STAFF REPORT: 8/09/2023 REGULAR MEETING PREPARED BY: J. ROSS

ADDRESS: 3964 W. LAFAYETTE **APPLICATION NO:** #23-8475

HISTORIC DISTRICT: HUBBARD FARMS APPLICANT/OWNER: JAMIE PEREZ DATE OF STAFF SITE VISIT: 7/18/2023

SCOPE: DEMOLISH WING, CONSTUCT NEW WING

3964 W. Lafayette, current appearance. Staff photos taken 7/13/2023

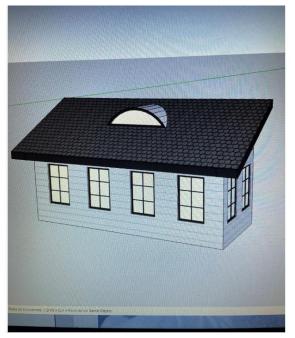
The building located 3964 W. Lafayette is structural clay tile dwelling that was erected ca. 1915. The home features a two-story, hipped-roof central/main mass with a projecting, two-story, hipped-roof wing at the rear. Arched and shed-roof dormers and a prominent stucco clad chimney top the building's main roof. The roof's deep, overhanging eaves include wood beadboard soffits and decorative jigsawn wood rafter tails. A shed-roof wing is located at the west side while a shedroof porte cochere is at the building's facade elevation. The west side wing and the east side porte cochere both display decorative jigsawn wood rafter tails within their eaves and distinctive clay tile parapets which are clad with stucco. Stucco clads the building's exterior walls while red brick is present at the foundation and windowsills. Lapped wood siding is located within several window openings and a door opening at the front of the west wing. Historic double-hung and casement wood windows with wood trim/brickmould remain at all facades, although some have been covered with plywood. Also, a small number of non-historic vinyl slider windows are visible. A review of files maintained by the HDC indicate that these non-historic windows were present at the time of designation. A partial width, brick and concrete porch with stone steps and historic-age iron railing is located at the building's primary facade. A 6'-0" high, metal chain-link fence encloses the property.
